# Access Compliance Report

## Public Rights-of-Way

Intersection ID: 20286	Main Street: LONGDALE_DR	Cross Street: S_TRYON_ST	Location: SE
ADA ID: F24B34178F88	Ramp Type: PerpDiag	Initial Pass/Fail: Pass	Overall Compliance: No
Severity Score: 10.25			
Codes/Mitigation Info/Possible Solution		Field Measurements/Component Compliance

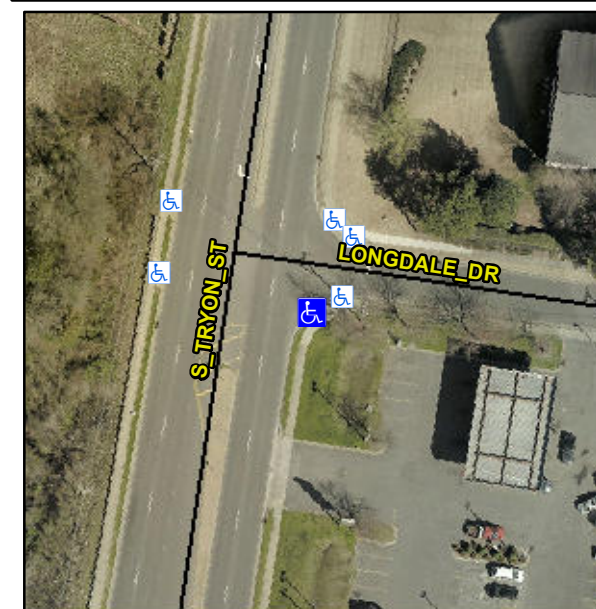
**Remove & Replace Curb Ramp With Two New Directional Ramps or Equivalent.**

**R304.5.3, R304.2.1, R304.2.2-Perp, R304.3.2-Para, R305.2**

Compliance	Description	Data	Compliance	Description	Data
N/A	Ramp Length (in)	87.0	Yes	Ramp Slope (%)	8.1
Yes	Ramp Width (in)	48.0	No	Ramp XSlope (%)	2.1
N/A	Flare Type LT	Sloped	N/A	Flare Type RT	N/A
N/A	Flare Slope LT (%)	6.9	Yes	Flare Slope RT (%)	5.4
N/A	Flare Traversable LT?	Yes	N/A	Flare Traversable RT?	Yes
No	Landing Length (in)	N/A	Yes	DWS Provided?	Yes
No	Landing Width (in)	N/A	Yes	DWS Contrast?	Yes
No	Landing Slope (%)	N/A	Yes	DWS Length (in)	24.0
No	Landing X Slope (%)	N/A	Yes	DWS Full Width?	Yes
N/A	Landing Curb? (Y/N)	No	No	DWS Offset (in)	4.0
N/A	Shared Landing?	No			
Yes	Gutter Ponding?	No	Yes	Gutter Slope (%)	2.1
Yes	Gutter Lip Ht (in)	0.0	Yes	Gutter X Slope (%)	0.6
N/A	Painted X Walk1?	No	N/A	Painted X Walk2?	No
	X Walk 1 Direction	To N		X Walk 2 Direction	To W
N/A	X Walk 1 Width (in)	N/A	N/A	X Walk 2 Width (in)	N/A
	X Walk 1 Slope (%)	0.6		X Walk 2 Slope (%)	1.9
	X Walk 1 X Slope (%)	1.6		X Walk 2 X Slope (%)	2.2
